TECHNICAL SERVICE BULLETIN

Technical Service Bulletin: 410-1371

Forest River is alerting you to an issue involving certain 2021 – COLUMBUS - CMF390RL, CMF390RLW, CMF392MB AND CMF392MBW fifth wheel travel trailer recreational vehicles. Please see the information below which describes the issue and provides you with details on the steps you should take to have your vehicle repaired.

TECHNICAL SERVICE BULLETIN 410-1371 REMEDY INSTRUCTIONS

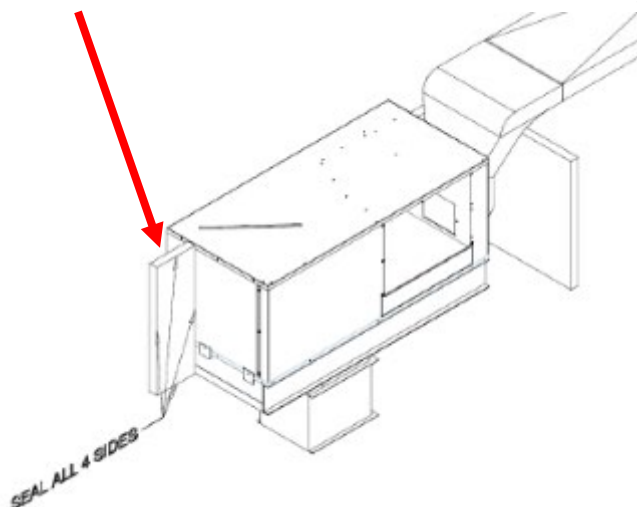
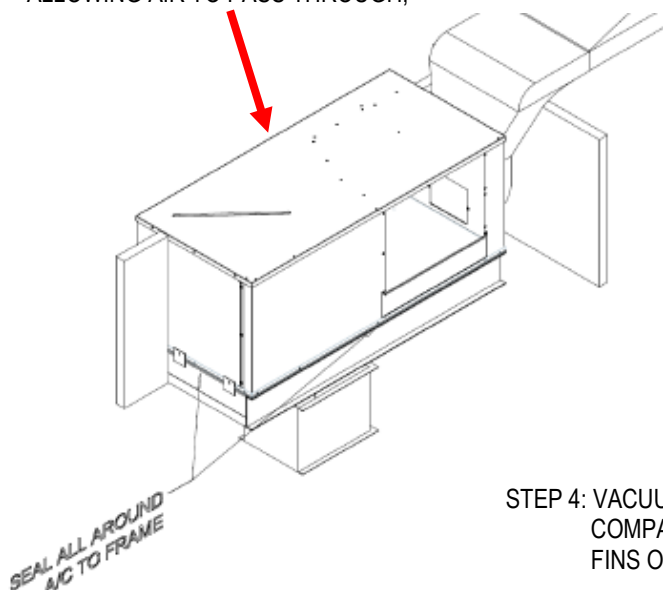
Possible poor seal insulation at the return air portion and/or air duct or trunk line of the air conditioner.

STEP 1: REMOVE THE PANEL ON THE BACKSIDE OF THE AIR CONDITIONER, WHICH IS ACCESSIBLE FROM THE REAR TRUNK DOOR. CHECK TO SEE IF A 1.5" FOAM PIECE IS BEHIND PANEL. THIS INSULATES AND ADDS STRENGTH TO THE PANEL TO PREVENT DAMAGE FROM STOWED ITEMS. ALSO, CHECK THAT FOAM WAS ADDED TO THE FRONT PORTION OF THE AIR CONDITIONER HOUSING;

STEP 2: REMOVE THE FOAM TO ACCESS THE DIVIDER PANEL. ENSURE THAT THE DIVIDER PANEL IS SEALED ON ALL FOUR SIDES;

STEP 3: CHECK ALL THE WAY AROUND THE AIR CONDITIONER, ALONG THE BOTTOM, TO BE SURE THAT IT'S SEALED TO THE MOUNTING FRAME. SCREWS IN THE FRAME CAN CAUSE THE AIR CONDITIONER TO BE LIFTED SLIGHTLY, ALLOWING AIR TO PASS THROUGH;

STEP 4: VACUUM OUT ANY FOAM BEADS THAT ARE LEFT IN THE COMPARTMENT, AS THEY TEND TO GET PULLED INTO THE REAR FINS OF THE AIR CONDITIONER.

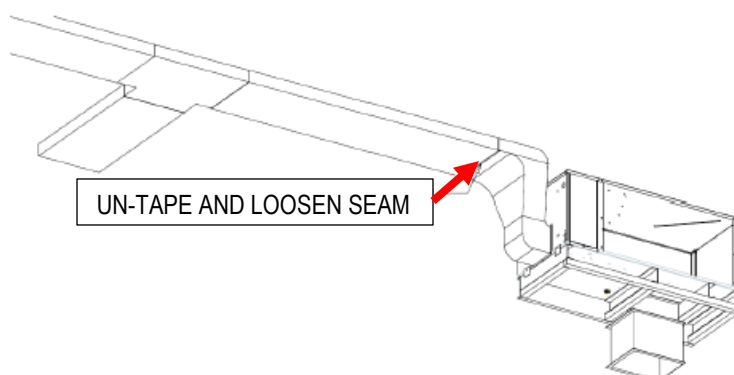
STEP 7: CHECK TO SEE IF AIR IS ESCAPING OUT OF THE DUCTING IN THE AREA SHOWN. THERE HAVE BEEN ISSUES WITH BUCKLING AT THE TOP AND AIR LEAKING. IF AIR IS LEAKING, SEE STEP 8 TO RESEAL;

STEP 8: TO RESEAL, PUSH THE BOTTOM OF THE DUCT UP TO REVEAL THE TOP SEAM. RUN 1/2" (MAX) SCREWS THROUGH THE UPPER SEAM INTO THE PLYWOOD FLOOR. BE SURE TO USE SCREWS 1/2" OR LESS TO PREVENT GOING THROUGH THE FLOOR. AFTER THE SEAM IS SECURED, RESEAL THE BOTTOM;
